Access Compliance Report

Public Rights-of-Way

(Curb Ramps)

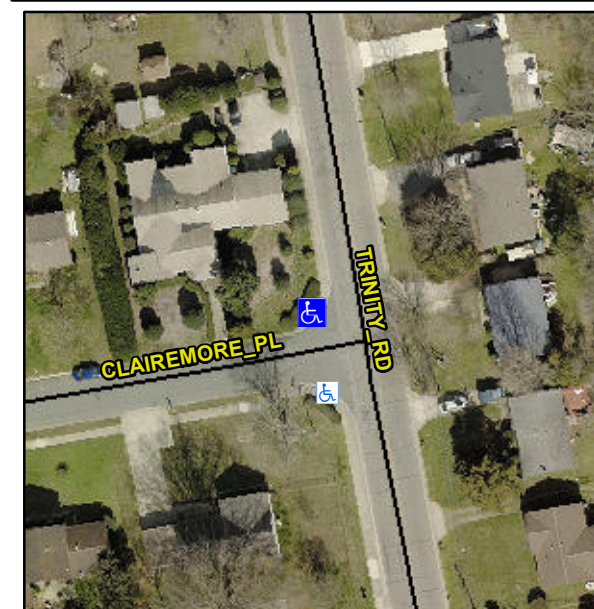
Intersection ID: 4615	Main Street: CLAIREMORE_PL	Cross Street: TRINITY_RD	Location: NW
ADA ID: 229C9570385C	Ramp Type: Perp	Initial Pass/Fail: Fail	Overall Compliance: No
Severity Score: 21.25			
Codes/Mitigation Info/Possible Solution		Field Measurements/Component Compliance

R304.5.1, R304.2.2

Compliance	Description	Data	Compliance	Description	Data
N/A	Ramp Length (in)	47.5	No	Ramp Slope (%)	9.5
No	Ramp Width (in)	40.5	Yes	Ramp XSlope (%)	2.0
N/A	Flare Type LT	N/A	N/A	Flare Type RT	N/A
N/A	Flare Slope LT (%)	N/A	N/A	Flare Slope RT (%)	N/A
N/A	Flare Traversable LT?	N/A	N/A	Flare Traversable RT?	N/A
N/A	Landing Length (in)	N/A	N/A	DWS Provided?	N/A
N/A	Landing Width (in)	N/A	N/A	DWS Contrast?	N/A
N/A	Landing Slope (%)	N/A	N/A	DWS Length (in)	N/A
N/A	Landing X Slope (%)	N/A	N/A	DWS Full Width?	N/A
N/A	Landing Curb? (Y/N)	N/A	N/A	DWS Offset (in)	N/A
N/A	Shared Landing?	N/A			
N/A	Gutter Ponding?	N/A	N/A	Gutter Slope (%)	N/A
N/A	Gutter Lip Ht (in)	1.0	N/A	Gutter X Slope (%)	N/A
N/A	Painted X Walk1?	No	N/A	Painted X Walk2?	N/A
	X Walk 1 Direction	To S		X Walk 2 Direction	N/A
N/A	X Walk 1 Width (in)	N/A	N/A	X Walk 2 Width (in)	N/A
	X Walk 1 Slope (%)	0.3		X Walk 2 Slope (%)	N/A
	X Walk 1 X Slope (%)	1.4		X Walk 2 X Slope (%)	N/A

Remove & Replace Entire Ramp.
